Re: 123 Wheeler St S, Ref. #111831 – Application for Appeal Addendum

This is to request consideration for the deficiencies that were included in the fire inspection correction notice.

Dryer exhaust vent:
Current transition duct length is ~79"
It connects to solid metal ductwork at the dryer and to the outside connection.

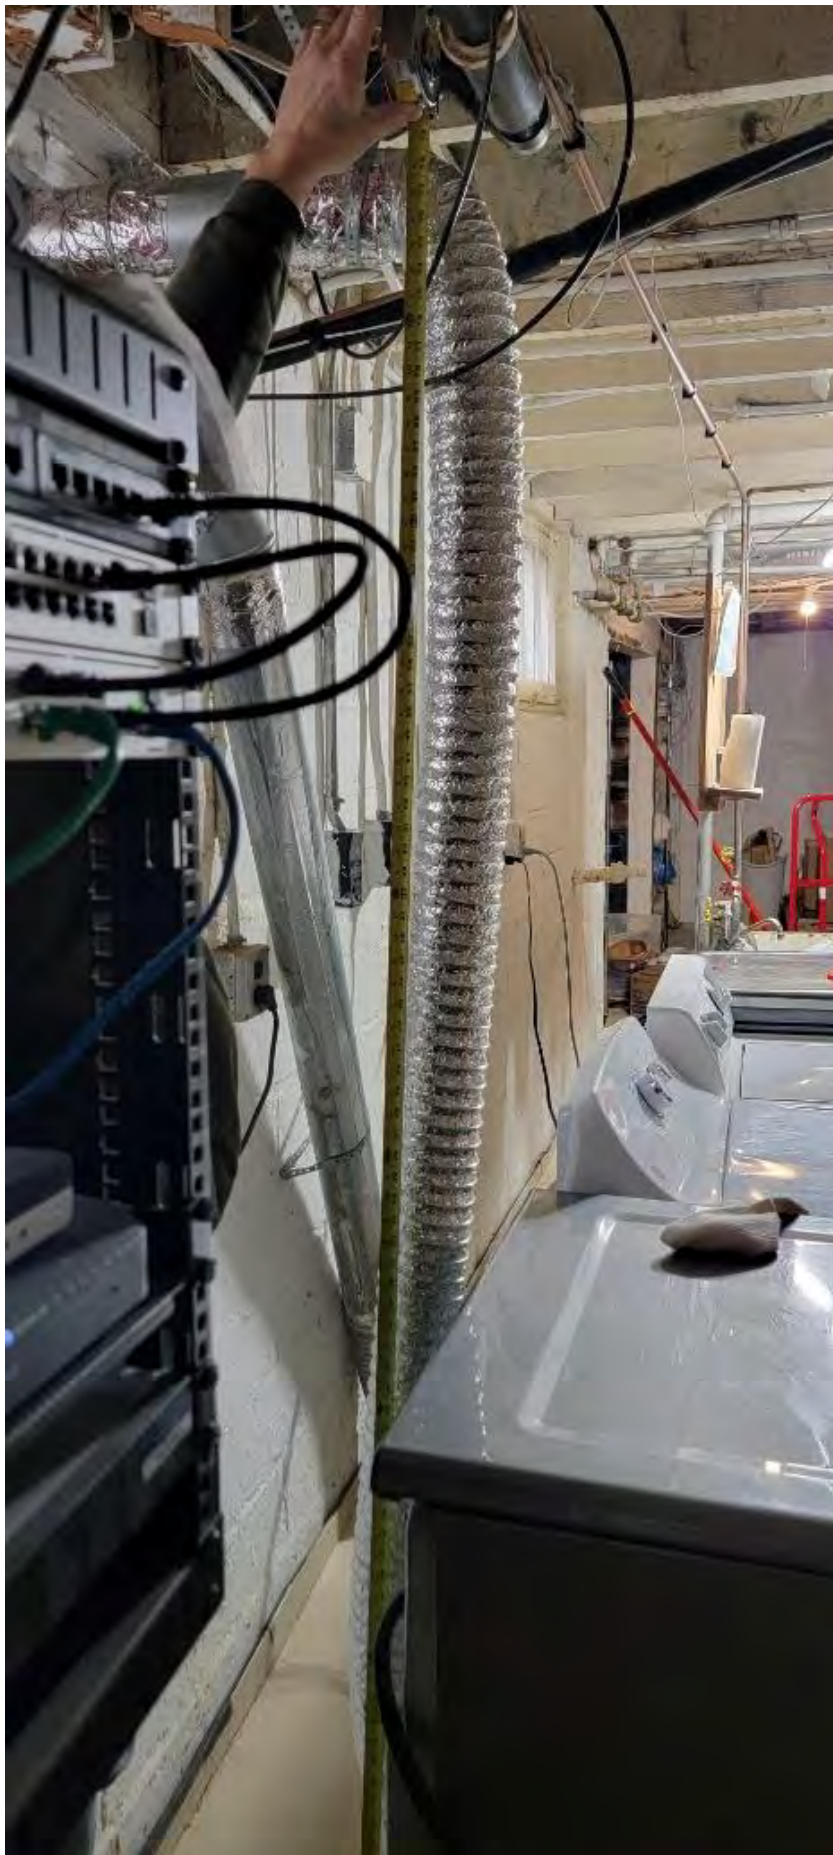
1. Dryer vent – notice states that flexible dryer vent is approx. 10 ft. Rakhma measures its current transition vent to be ~79" (see photo at end of document). The connection from the dryer as well as to the outside is solid metal and does not contain any screws. The vent is not concealed within construction. It is our understanding that code allows up to 8 ft for transition vent based upon the following (2020 Minnesota Mechanical and Fuel Gas Code 504.8.3 Transition ducts): "Transition ducts used to connect the dryer to the exhaust duct system shall be a single length that is listed and labeled in accordance with UL 2158A. Transition ducts shall be not greater than 8 feet (2438 mm) in length and shall not be concealed within construction." (<https://www.dli.mn.gov/business/codes-and-laws/2020-minnesota-state-building-codes>) *fyi... we were unable to find the code on the City of St. Paul website.*

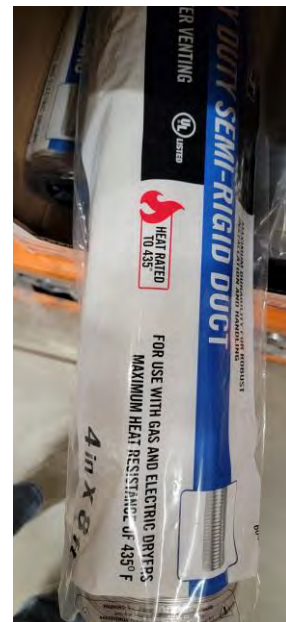
During the hearing on Tuesday, May 7, 2024 we were asked to provide the UL Listing on the material. Here is what was purchased:
